# 1980 YOUNTVILLE CROSS ROAD

Zoning and Design Review Board  
April 9, 2024

## SDBL Waivers

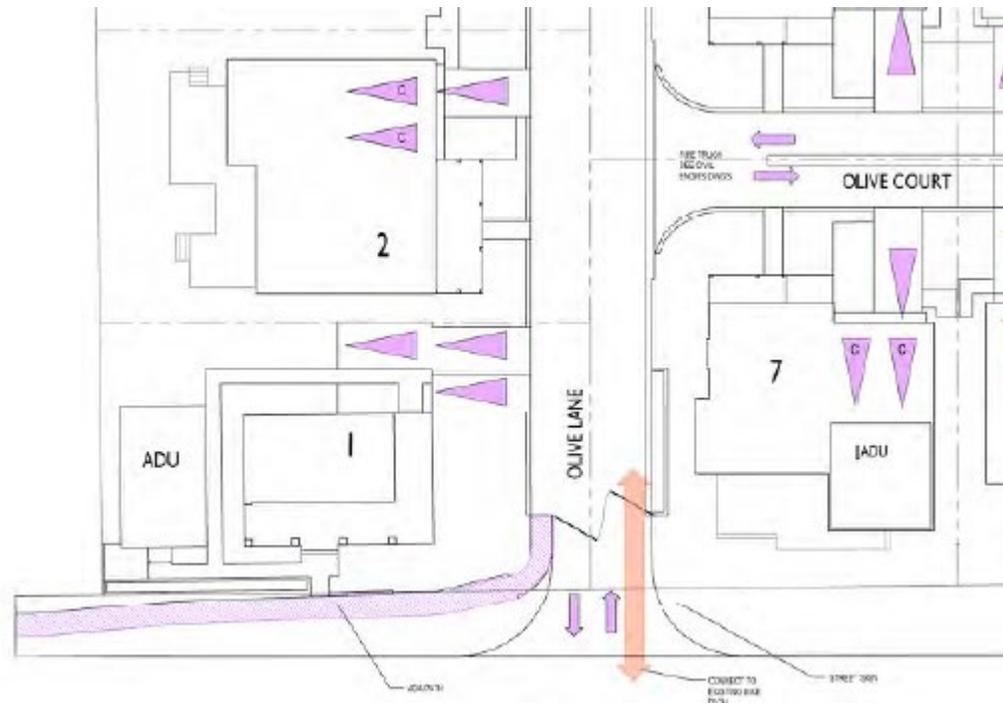
- **Waiver 3:** Exceed the height limit to allow for more than 50% of the parcels on the block to have a second story. Exceed Yountville Municipal Code (YMC) Table 17.20-1 requirement that no more than 50% of parcels containing single-family or duplex units in any block may exceed one story in height.
- **Waiver 4:** Exceed Table 17.20-1 FAR Requirements of 0.30 for a living area of a single-family residence and 0.35 including the garage.

## Street Standards

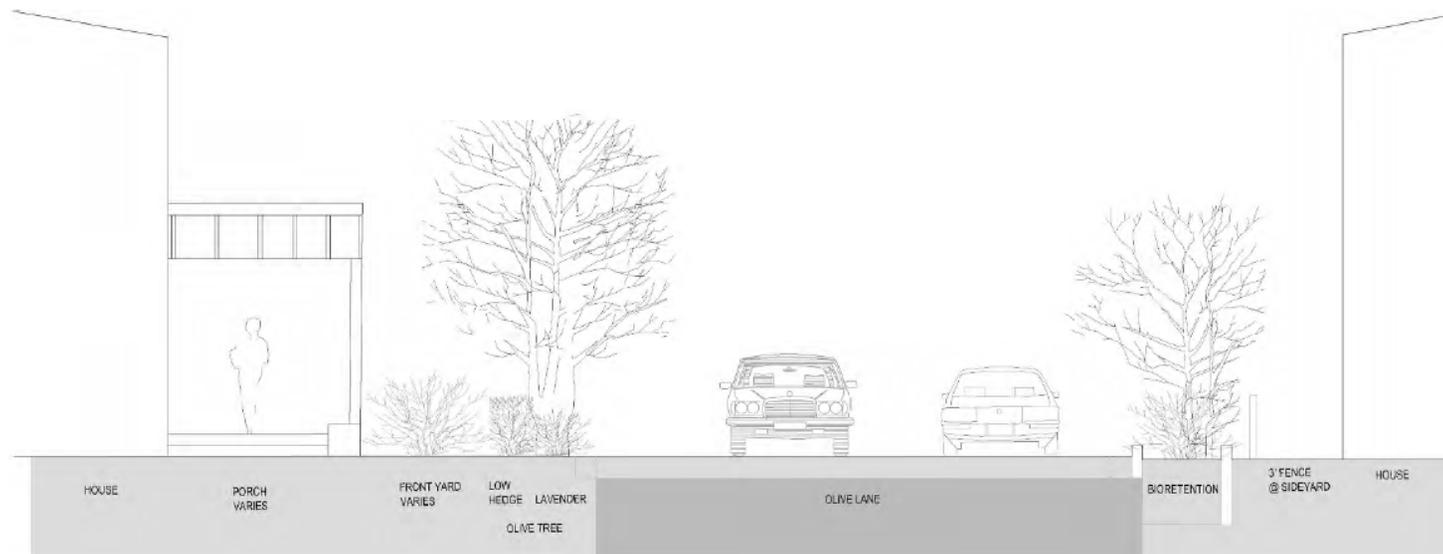
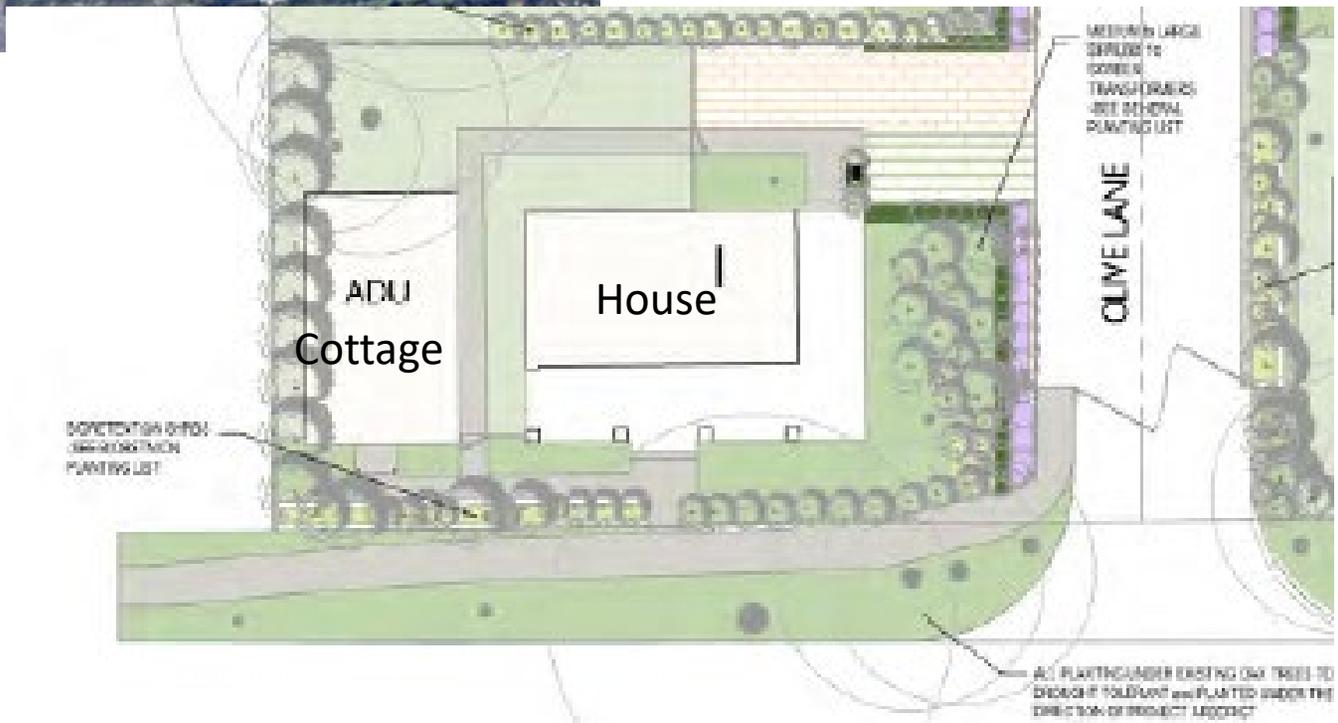
**Waiver 1:** Install a private road with two-way travel lanes without on-street parking, sidewalks, and landscape medians.

**Waiver 2:** Relief from installing a sidewalk on the project frontage along Yountville Cross Road between the eastern property line and the new access road.
